September 6, 2011

**Addendum No.2**

Addition to Buildings 131 &138  
Bethany Beach Training Site  
Delaware National Guard  
Bethany Beach Delaware  
DEARNG Contract No. 11-2010  
DBF No. 0999J003

# PARTIAL FLOOR PLAN

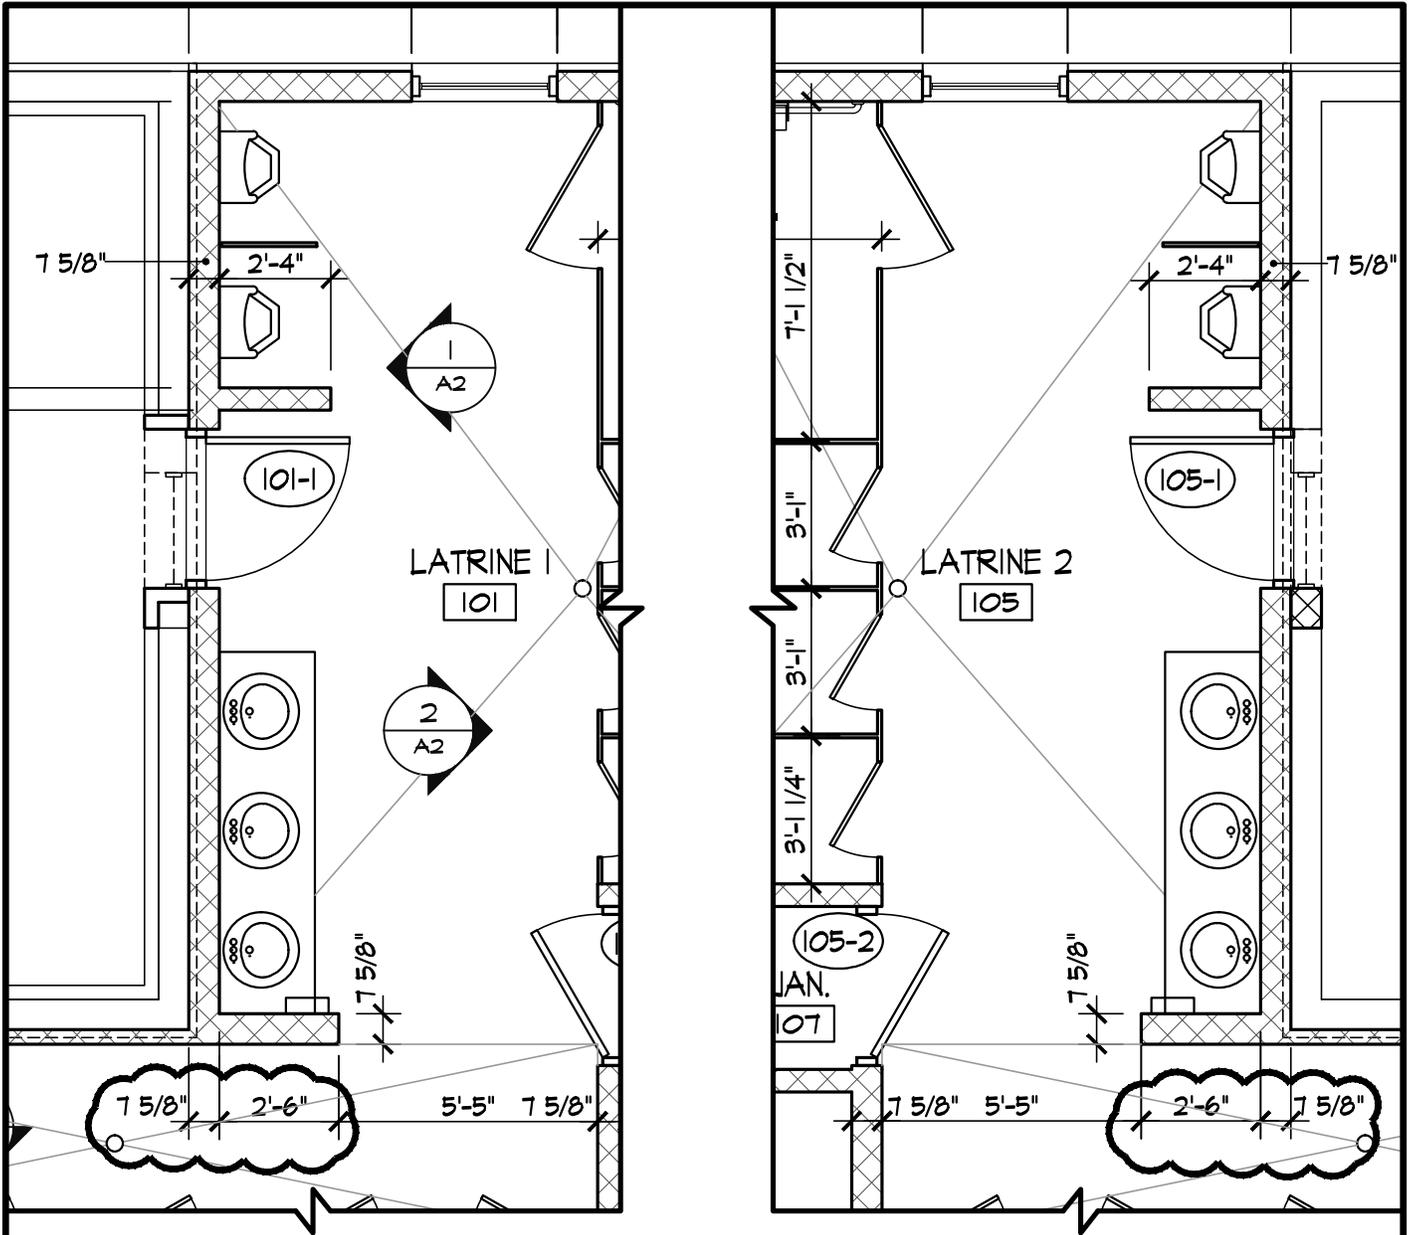
4. I am concerned that the drawings indicate domestic water and drain lines run within a single wythe of CMU wall. Cores are grouted and reinforced at 16" centers - this will be

difficult, if not impossible, to accomplish in a 6" CMU wall. Please review and confirm if this is how we should proceed with our bid.

**Answer: The 6 inch cmu wall behind the lavatories will be revised to be 8". The cores are to be reinforced with vertical reinforcing bars at 48 inches on center per the drawings. See attached sketch for plan revision.**

Dwg.No.:  
 SK 8-30A

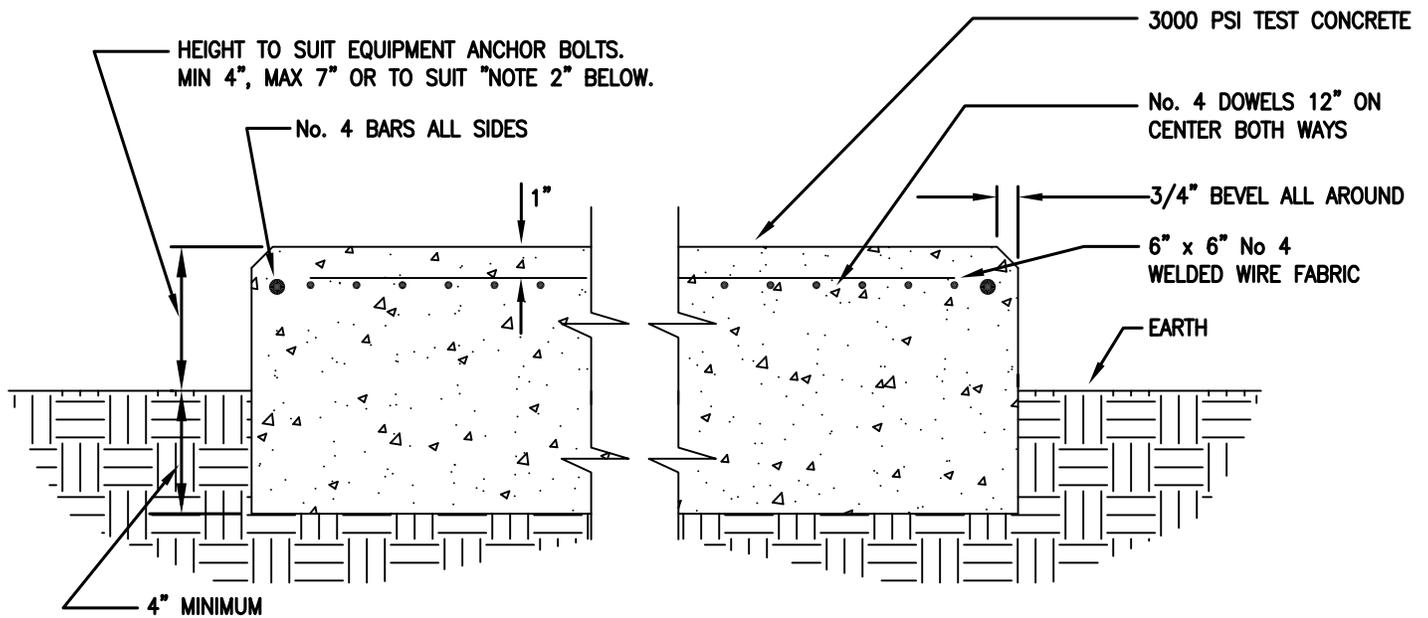
1. Plumbing drawings indicate a 6" sanitary line under the 12" CMU common wall between the latrines. What is the elevation of this line with respect to the new footing required to support the new wall?

**Answer: See attached sketch for the solution. Pipes going under the footing are to be placed in pipe sleeves. The footing can be raised 4" if the project requires due to building sewer depth (to be located in field by the contractor). The first course of 12 inch cmu would be 4 inches instead of 8 inches high and there would be no thickened slab.**

## CONCRETE PAD FOR LIGHT EQUIPMENT DETAIL

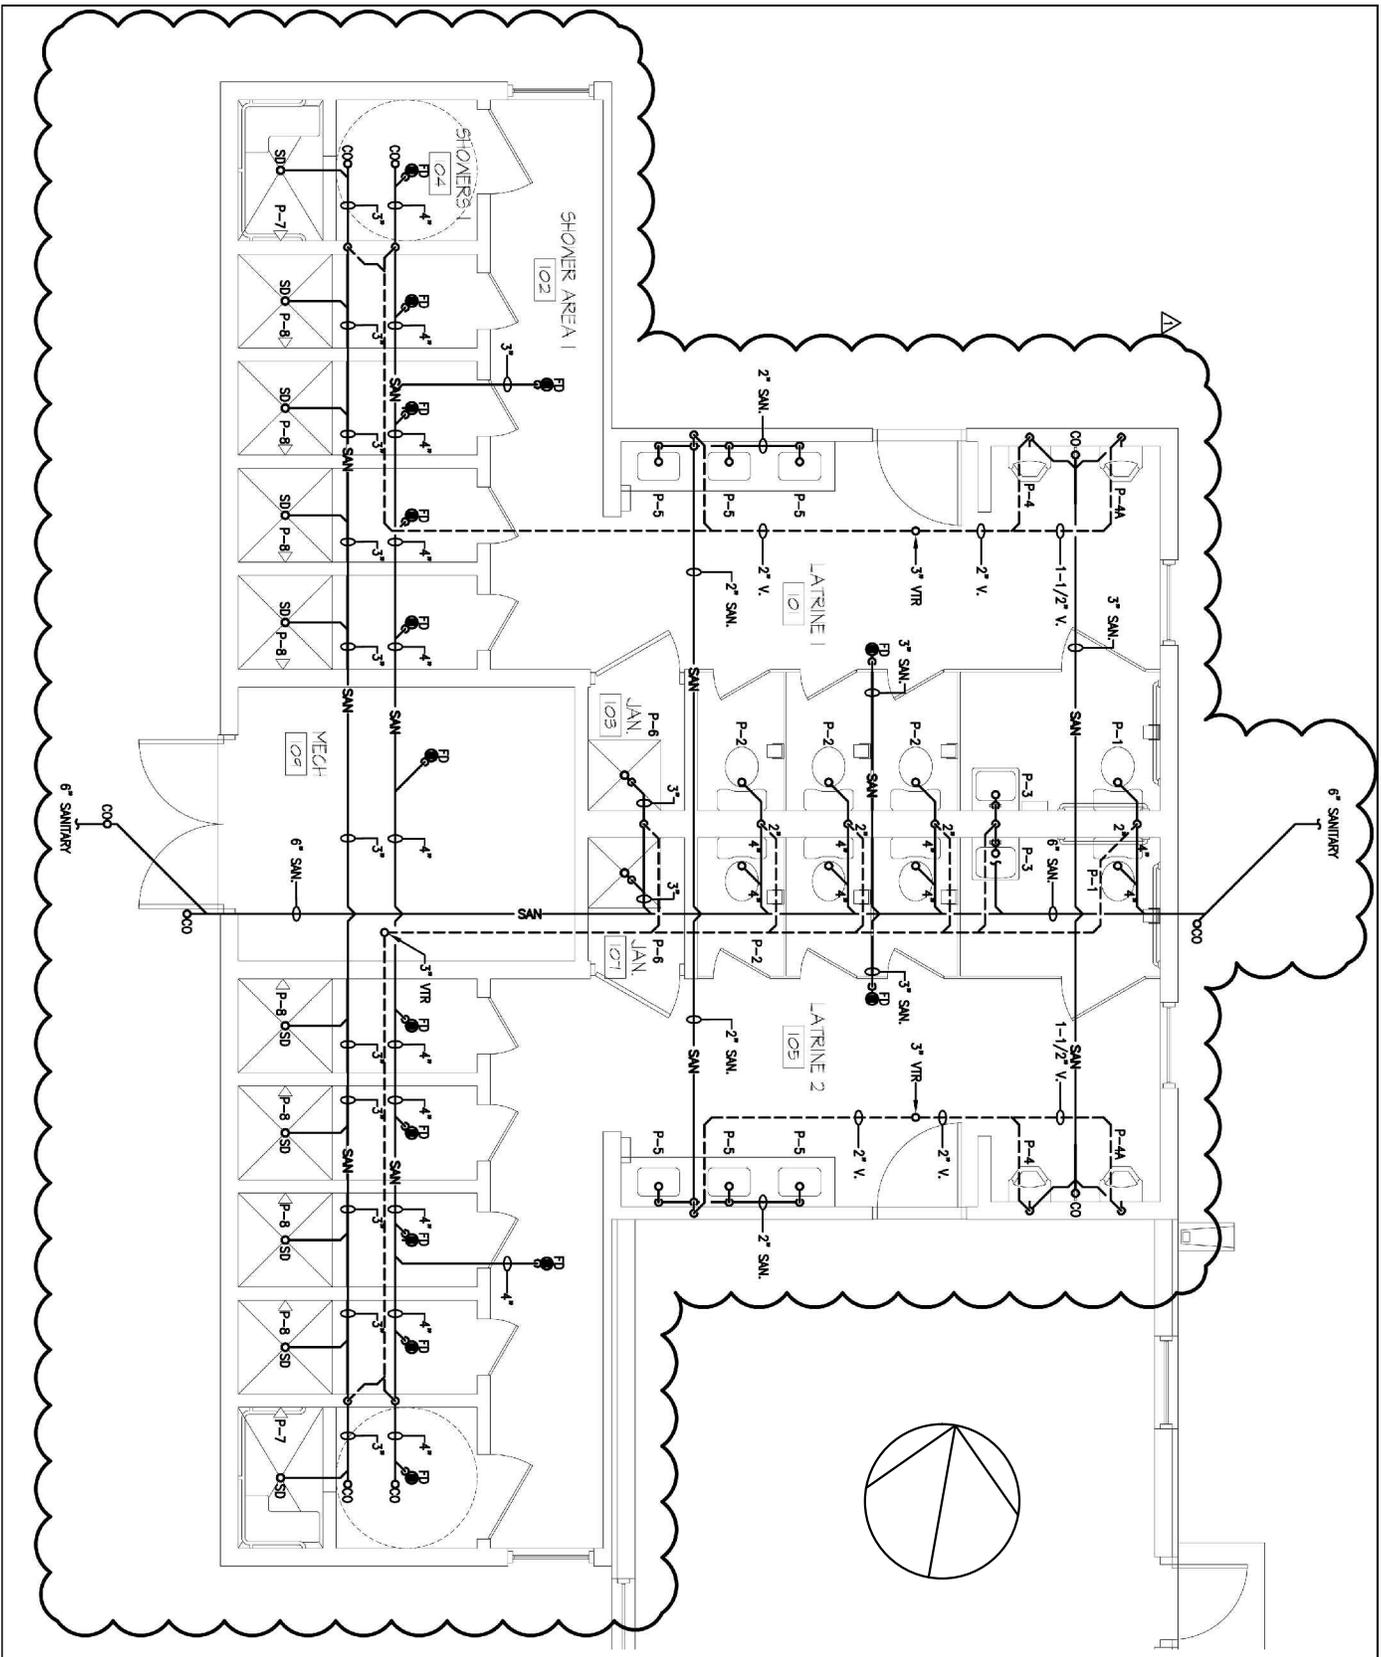
3. Drawing M-1 Mechanical Plan- Regarding RTU #1, detail is needed of how duct enters the existing building for roof or wall penetration. Will unit set on a concrete pad? If so, need detail for pad with size, ect.

**Answer: Duct Detail located on the S1 drawing, referenced from A1. See attached**

**detail for concrete pad.**

- 1) PAD DIMENSIONS AND SIZE MUST SUIT EQUIPMENT ACTUALLY INSTALLED. EDGE OF PAD SHALL BE 6" MINIMUM FROM EDGE OF EQUIPMENT.
- 2) HEIGHT OF PAD MUST BE SUFFICIENT TO ACCOMMODATE ANY DRAIN PIPING AT THE INSTALLED EQUIPMENT.
